## NRC Resolution of Facility Comment

### Facility Comment on Q57

### Question 57

NSA Position Control Group On / Backup Heaters in Auto

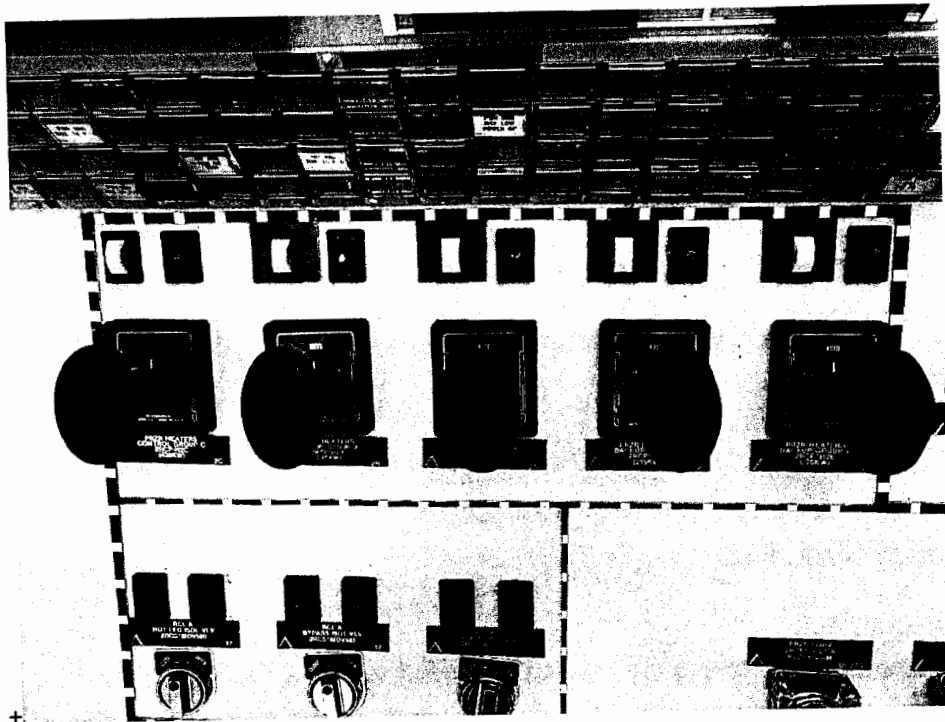
Given the plant conditions in the stem of the question (specifically the 8% PRZR level insurge), the Proportional heaters would remain ON and deenergized (benchboard red light illuminated but no output based on the 42% output of 2RCS-PK444) AND the Backup heaters would be ON and energized (benchboard red lights illuminated due to the 8% PRZR level insurge). See attached images reflecting NSA and conditions after the 8% PRZR level insurge.

If the candidate approached the question strictly focusing on the Proportional heaters still being ON, then answer "B" is correct.

If the candidate approached the question focusing on which heaters were energized, then "C" is still a correct answer.

Facility comment accepted, two correct answers accepted. Five applicants missed the question. The examiner reviewed documentation provided by the facility, exam bank questions for this system, and the system lesson plan. All use the “energized” or “deenergized” terminology to describe whether or not the heaters are powered, and “ON” or “OFF” for breaker position.

NSA Position Control Group On / Backup Heaters in Auto

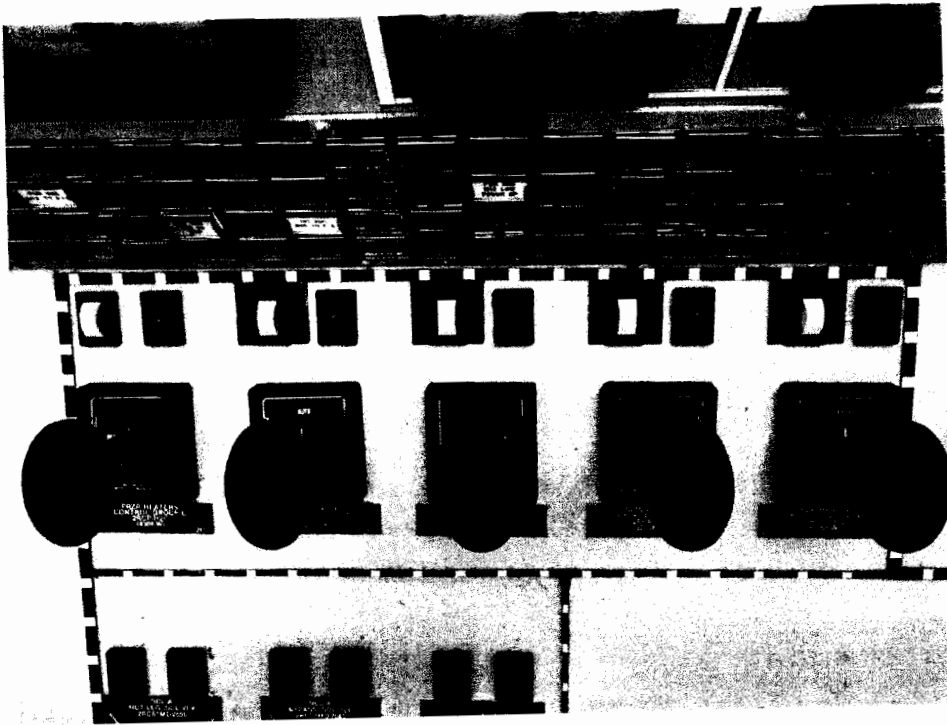
Given the plant conditions in the stem of the question (specifically the 8% PRZR level insurge), the Proportional heaters would remain ON and deenergized (benchboard red light illuminated but no output based on the 42% output of 2RCS-PK444) AND the Backup heaters would be ON and energized (benchboard red lights illuminated due to the 8% PRZR level insurge). See attached images reflecting NSA and conditions after the 8% PRZR level insurge.

If the candidate approached the question strictly focusing on the Proportional heaters still being ON, then answer "B" is correct.

If the candidate approached the question focusing on which heaters were energized, then "C" is still a correct answer.
